**FINDINGS AND RECOMMENDATION
OFFICE OF PLANNING AND ZONING
ANNE ARUNDEL COUNTY, MARYLAND**

CASE NUMBER: 2025-0129-V

The applicants are requesting a variance to allow a dwelling addition (four season room) with less setbacks than required and with new lot coverage nearer to the shoreline than the closest façade of the existing principal structure at 3002 Valley View Road in Annapolis.

E-1	SHEET:	3/8"=1'-0"	SCALE:	6/11/25	DATE:	DRAWINGS PROVIDED BY: READY TO SELL RENOVATIONS	PROJECT DESCRIPTION: 3002 VALLEY VIEW RD ANNAPOLIS MD 21401	SHEET TITLE: EXISTING & PROPOSED ELEVATIONS

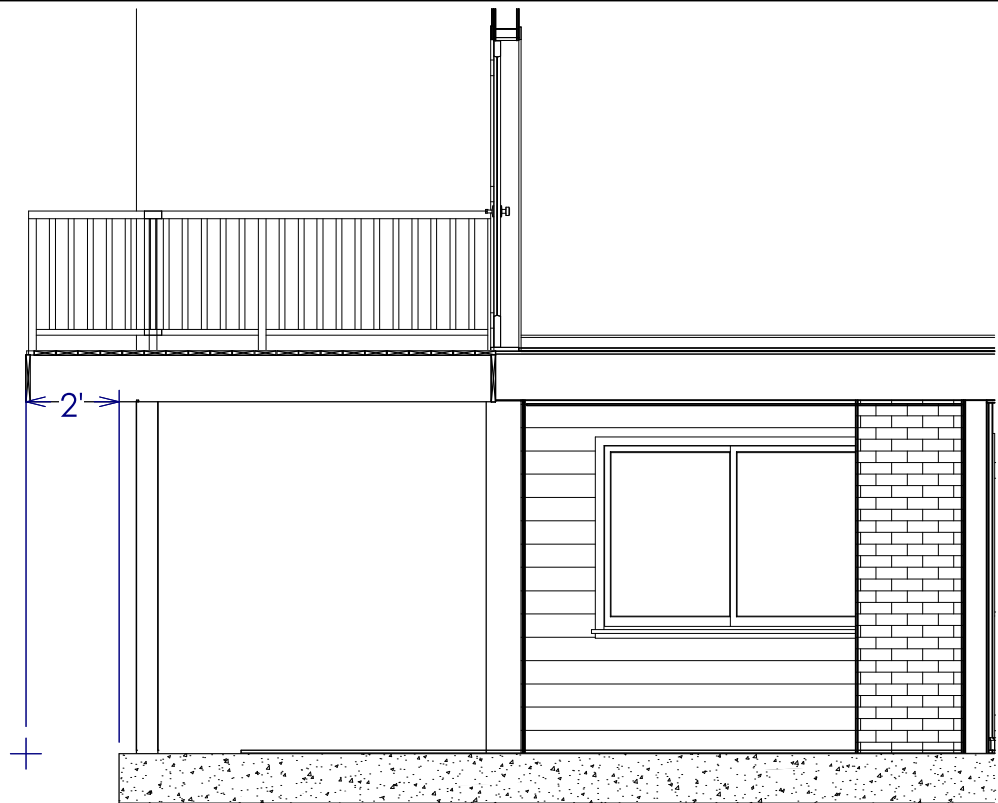
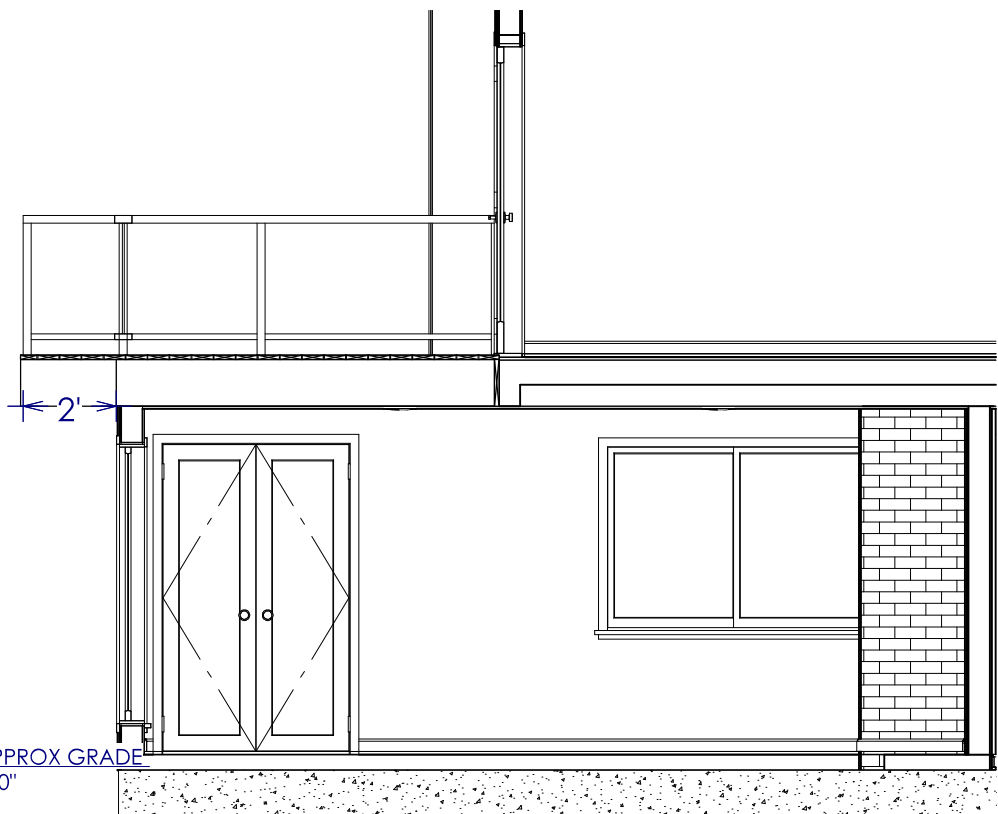
The **Development Division (Critical Area Team)** commented that there is no objection to this proposal provided the enclosure is constructed in the manner depicted on the architectural drawings submitted with this application and result in no permanent or temporary steep slope disturbance.

No objection to this proposal provided the enclosure is constructed in the manner depicted on the architectural drawings submitted with this application and result in no permanent or temporary steep slope disturbance.

*DECKING ABOVE WILL BE REMOVED AND A PITCHED MEMBRANE ROOF WILL BE INSTALLED ON EXISTING JOIST SYSTEM

**NEW EXTERIOR WALL FRAMING WILL NOT REQUIRE ANY ADDITIONAL GROUND DISTURBANCE

***ONLY ENCLOSING EXISTING SPACE

****EXISTING FOOTINGS AND 6X6 POSTS CURRENTLY SUPPORTING EXISTING DECK WILL REMAIN IN PLACE

2X6 WALL CONSTRUCTION
 -NEW WALLS FRAMED BETWEEN EXISTING 6X6 POSTS
 -TOP OF EXISTING CONCRETE SLAB TO FACILITATE THE ENCLOSURE WITH PRESSURE TREATED BASE PLATE
 -VINYL SIDING
 -1/2" ZIP SYSTEM WALL SHEATHING
 -2X6 WOOD STUD
 -R-21 BATT INSULATION
 -1/2" GYP. BOARD
